Planning Commission Hearing Date: May 5, 2026
Board of Commissioners Hearing Date: May 28, 2026

STAFF ANALYSIS

CASE NO.:	Z-26-1247887	File ID #: 2026-0449
Address:	705 & 711 Hillmont Avenue, Decatur, Georgia	Commission District: 04 Super District: 06
Parcel ID(s):	15-248-07-017 & 15-248-07-020	
Request:	Rezone properties from the C-1 (Local Commercial) Zoning District and to the R-60 (Residential Small Lot -60) Zoning District to construct a new single-family residence.	
Property Owner(s):	William McGrier	
Applicant/Agent:	Ray Bachan / My Next Home Pro, LLC	
Acreage:	0.15 acre	
Existing Land Use:	Single-Family Home	
Surrounding Properties:	North: Commercial (within City of Avondale Estates) South: R-75 East: R-75 West: R-75	
Adjacent Zoning:	R-75 (Residential Small Lot-75)	
Comprehensive Plan:	Commercial Revitalization Corridor (CRC) Consistent <u>X</u> Inconsistent

STAFF RECOMMENDATION: APPROVAL WITH CONDITIONS.

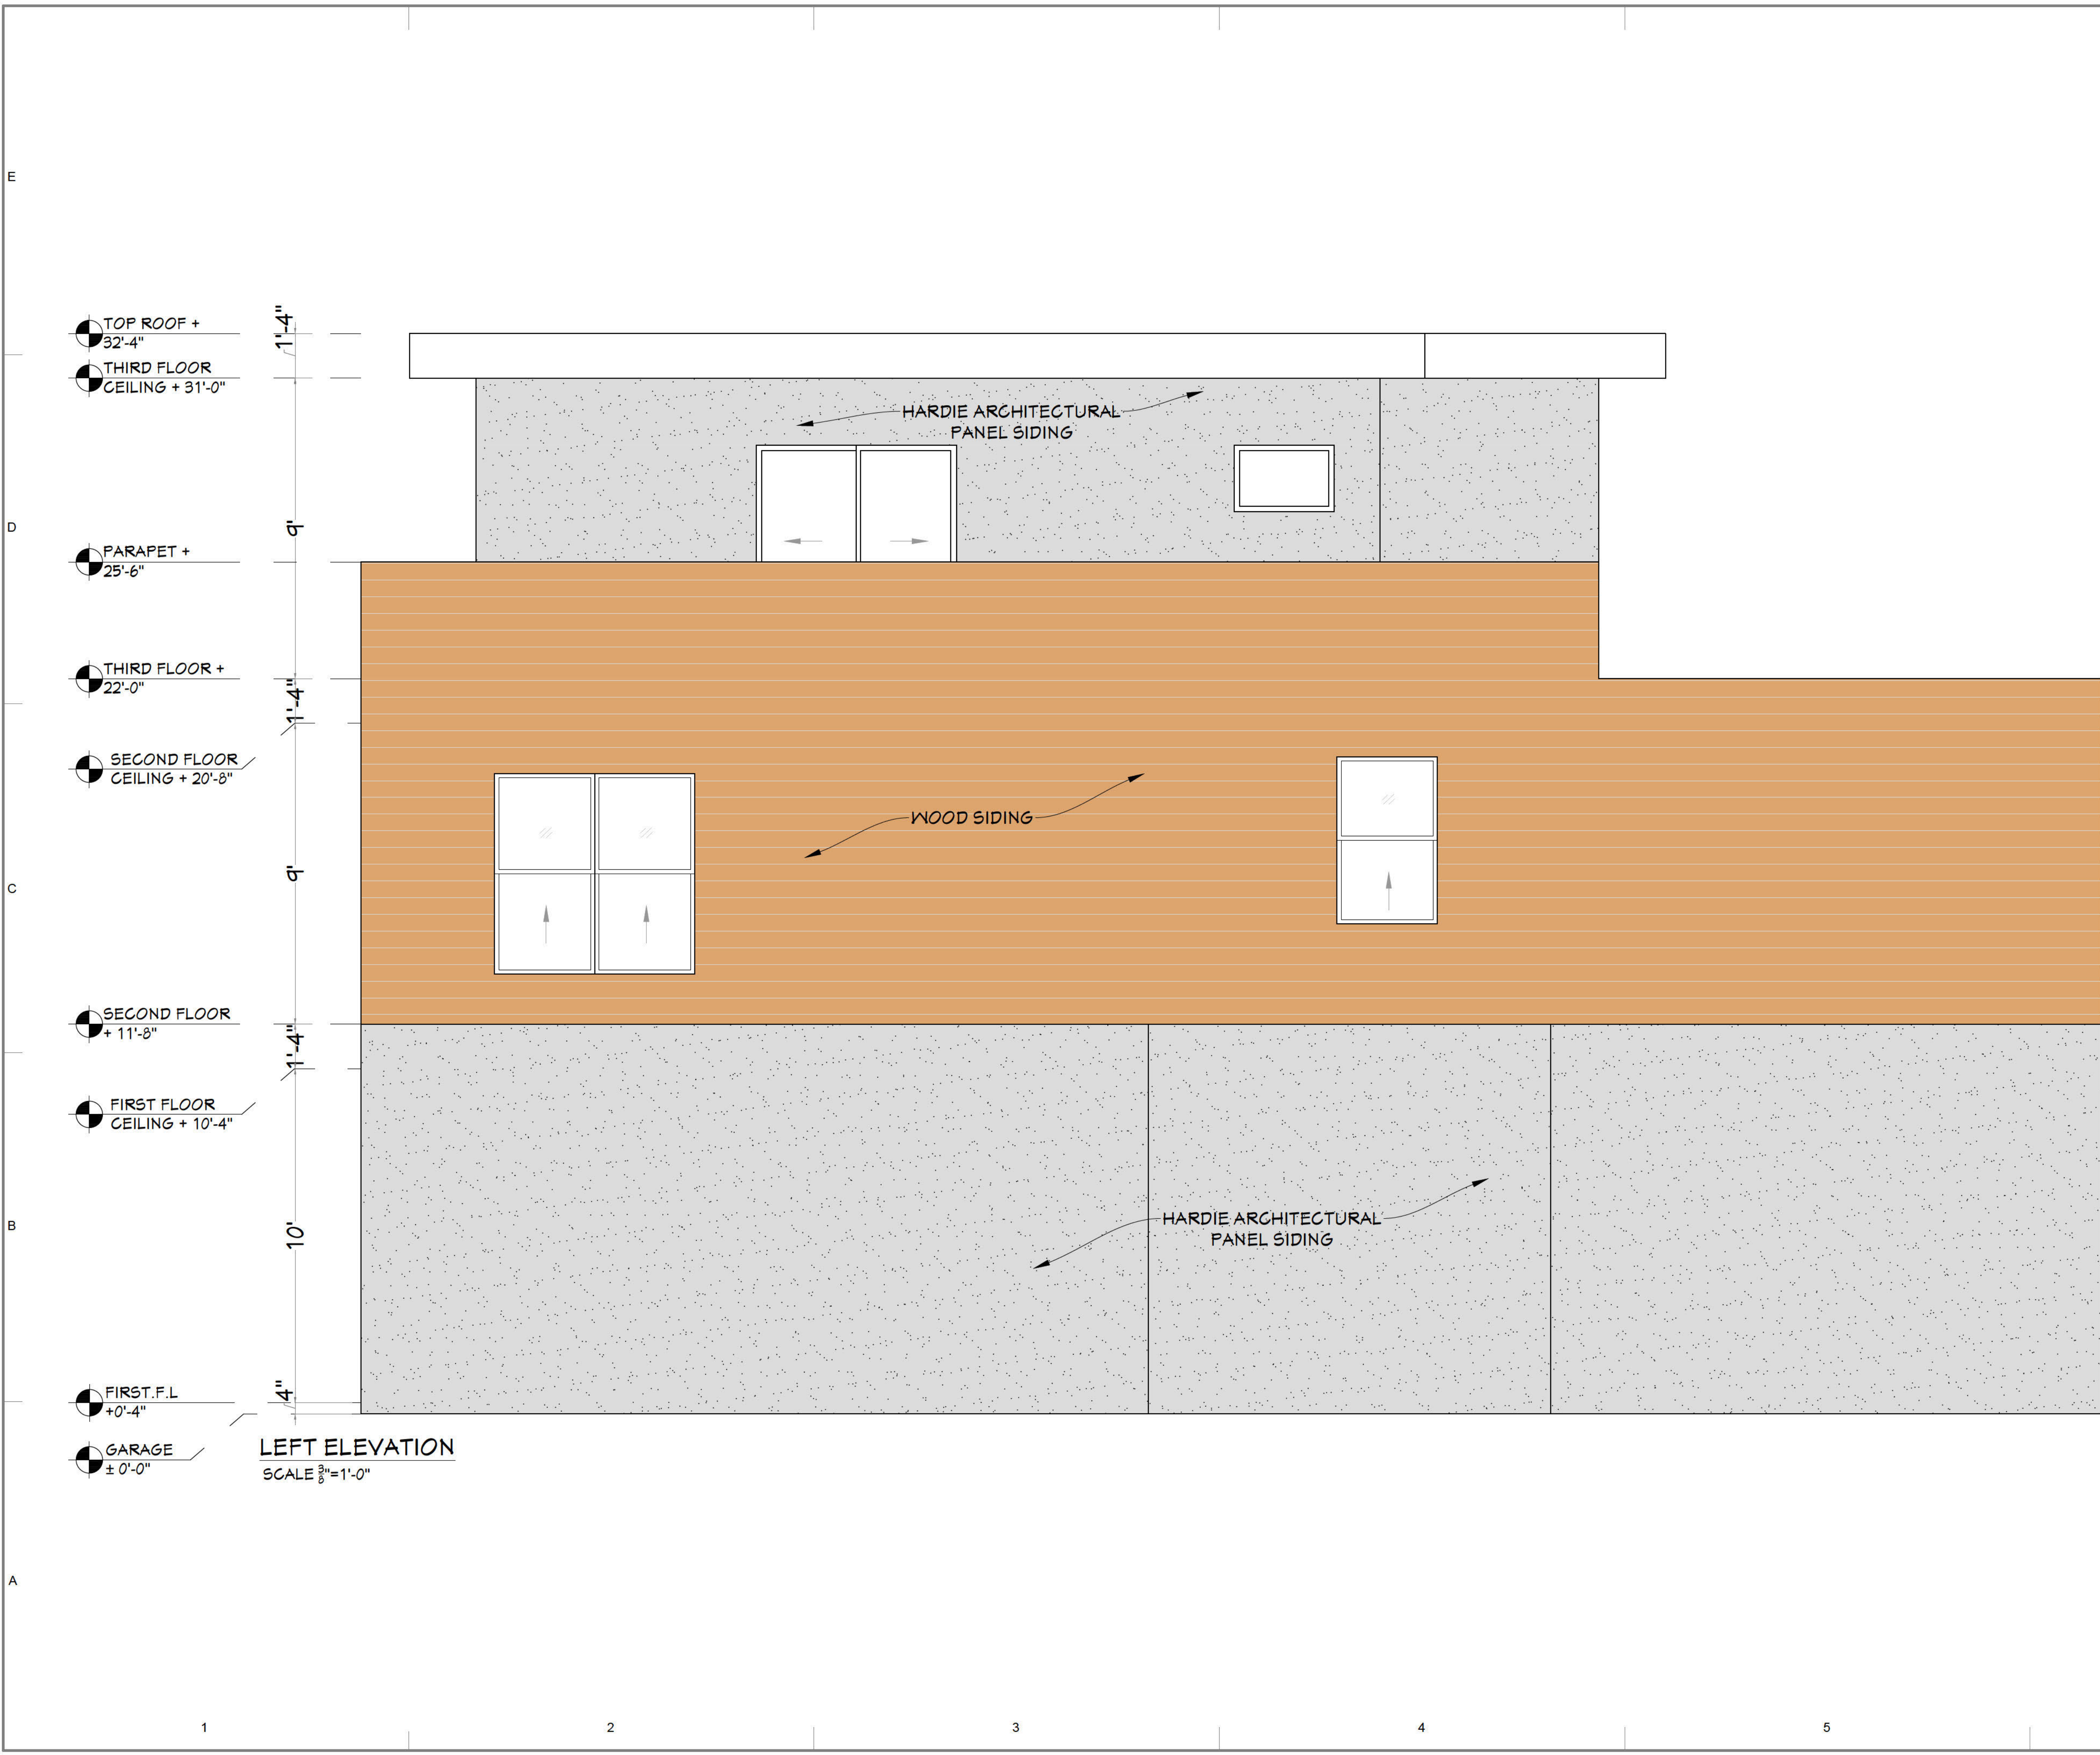
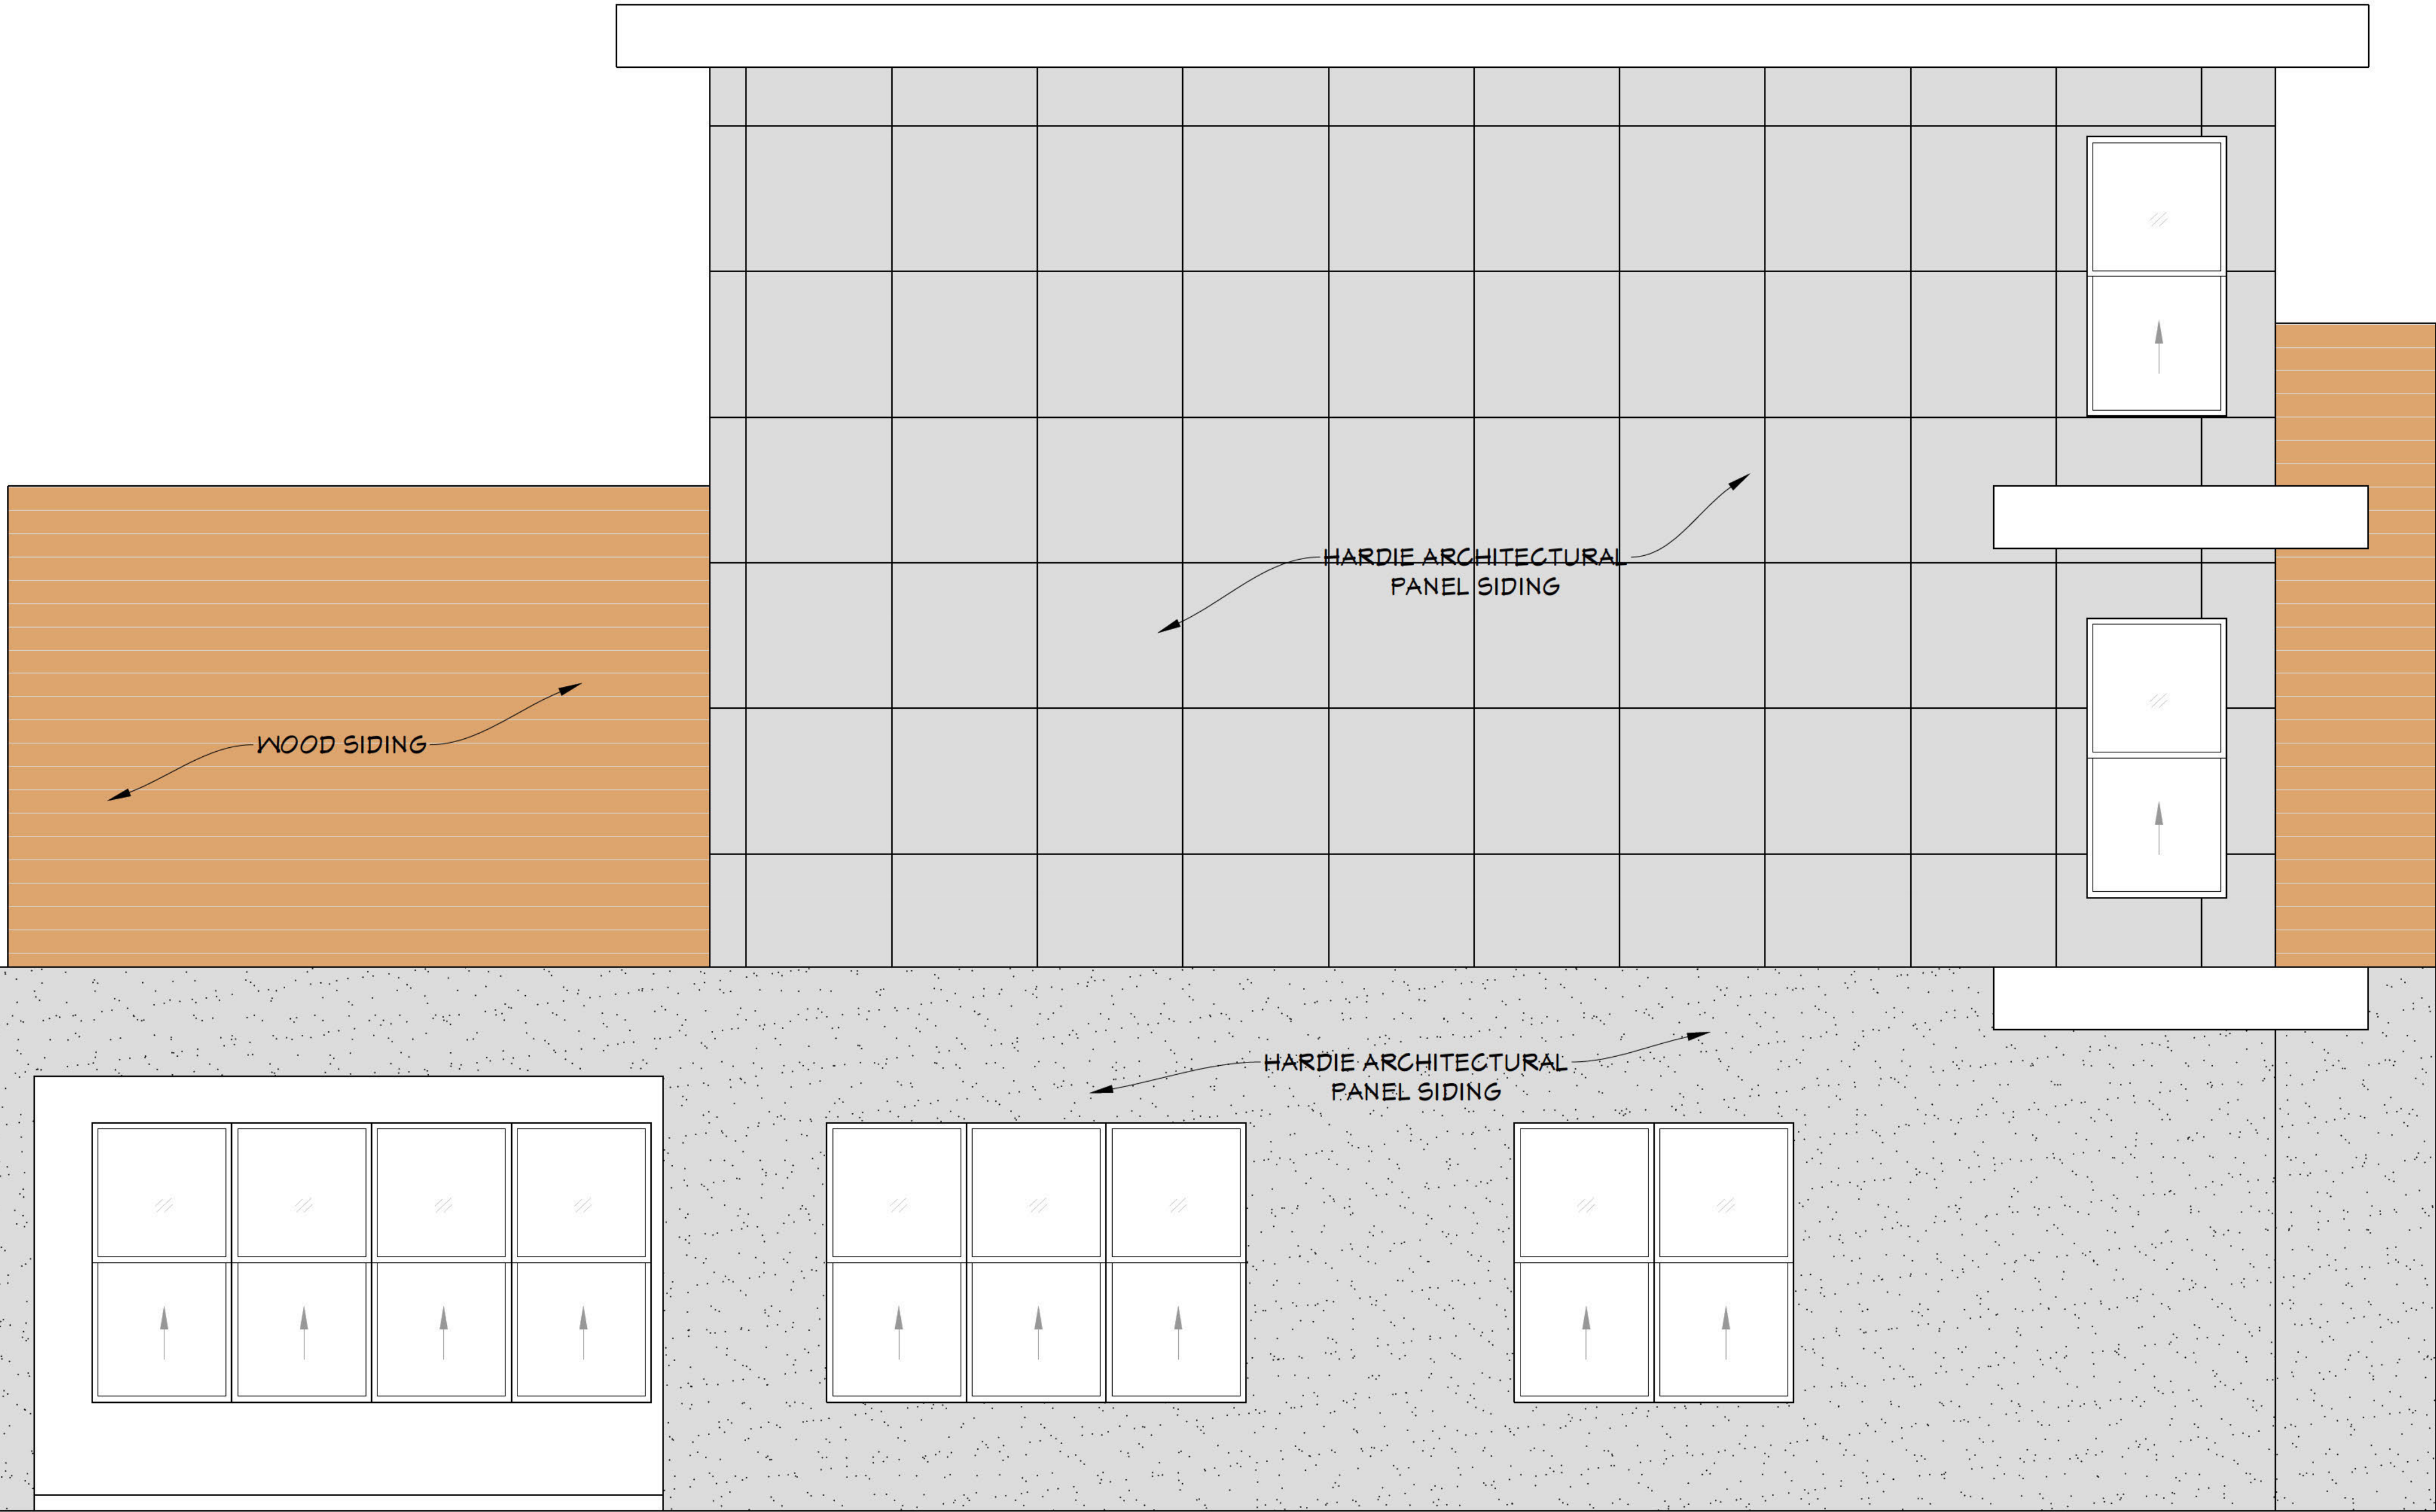
While the rezoning is consistent with the neighborhood, the proposed architectural design may not align with the existing development pattern along Hillmont Avenue. Accordingly, considerations to the re-design have been proposed by Staff to better align with the architectural character of the TN Character Area. Therefore, upon review of Section 5.3.4 (Rezone criteria A-N) of the Zoning Ordinance, Staff recommends ***"Approval with the following conditions":***

- 1) The architectural plan will be redesigned to reflect a design that satisfies the intent and goal of the Traditional Neighborhood (TN). Such design will require written approval from the Planning Deputy Director prior to any permit.
- 2) A 5-foot landscape strip and 5-foot sidewalk must meet the requirements of Section 5.4.3 (Streetscape Elements and Dimensions) of the Zoning Ordinance, prior to the issuance of the Certificate of Occupancy (C/O).
